## Oconee Nuclear Station

Duke Energy Presentation to the NRC Committee to Review Generic Requirements (CRGR) – October 24, 2017

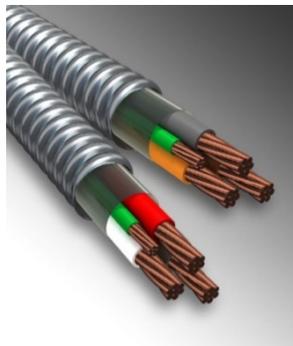
- The draft TIA position documented in Question 2.j does not address Duke Energy's licensing history and accepted practices in regards to armored cable.
- Oconee's cable design and installation practices, including routing and separation distances, were based upon the NRC accepted use of armored cable.

Armored cable may not be credited with respect to cable separation.

- Separation is accomplished through the use of distance and/or barriers. Information on cable routes, separation distances, cable construction (including armor), and barriers has been contained within Oconee FSAR Chapters 7 & 8 since initial licensing.
- Oconee SERs for initial licensing document that the provisions for installation and separation of cables were reviewed and found to be acceptable.
- In addition to the Oconee FSAR content, Oconee correspondence to the AEC on 12/22/1970 described the philosophy around the use of armored cable. The Duke Energy design incorporates cable armor to serve as a protective barrier that acts in much the same manner as flexible conduit. Essentially, each cable has its own conduit “built-in” by the armor.

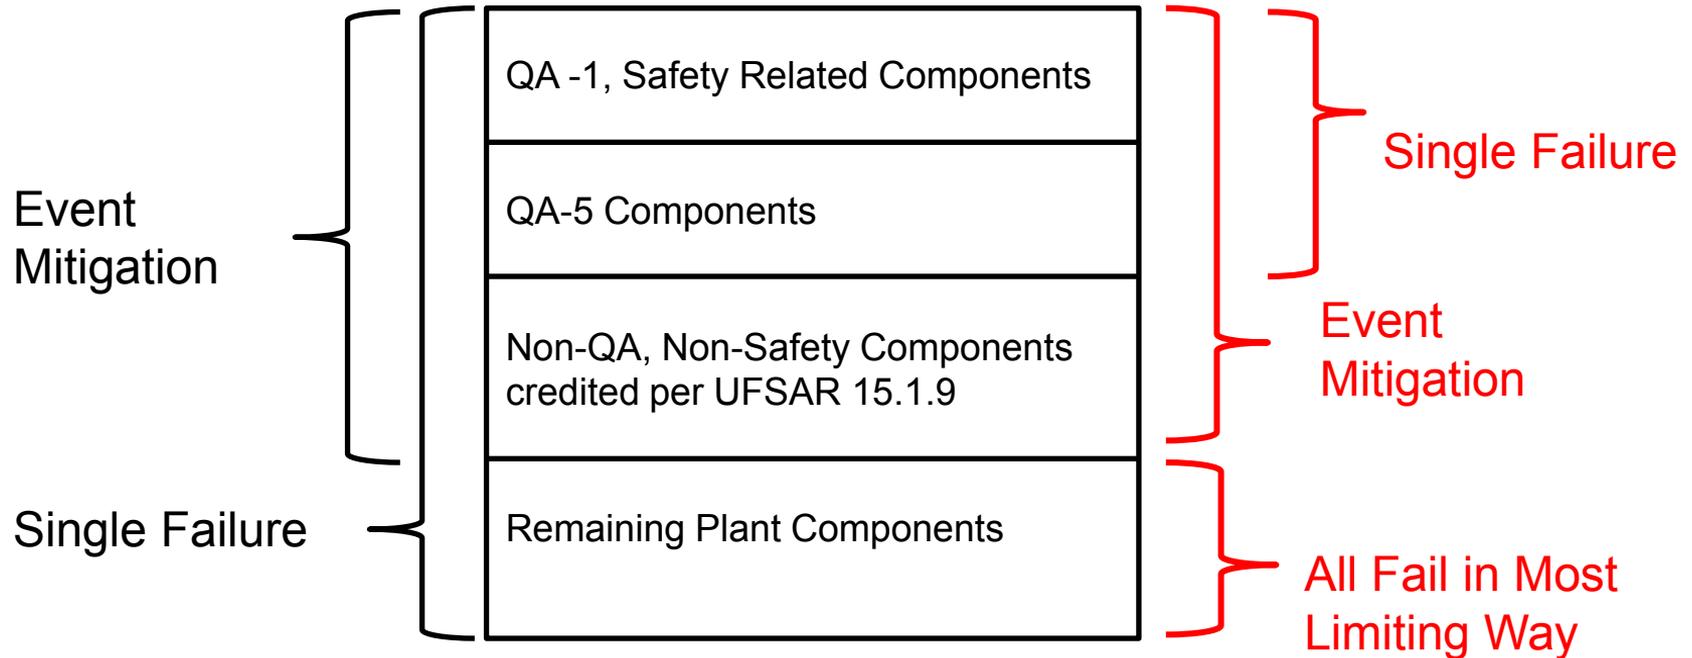
- All commercial, non-quality related (i.e. not QA-1 or QA-5) electrical components are assumed to fail in the most limiting way possible.
- These failures must be considered in addition to the single failure of Class 1E equipment.
- The licensee may not credit any non-safety equipment unless it is specifically evaluated and approved in the plant licensing basis.

All non-safety related electrical components are assumed to fail in the most limiting way in addition to the Single Failure.

- The requirement to consider the failure in the most limiting way of all Non-QA equipment coincident with one single failure of Class 1E equipment is not supported by Oconee's licensing basis for single failure analysis.
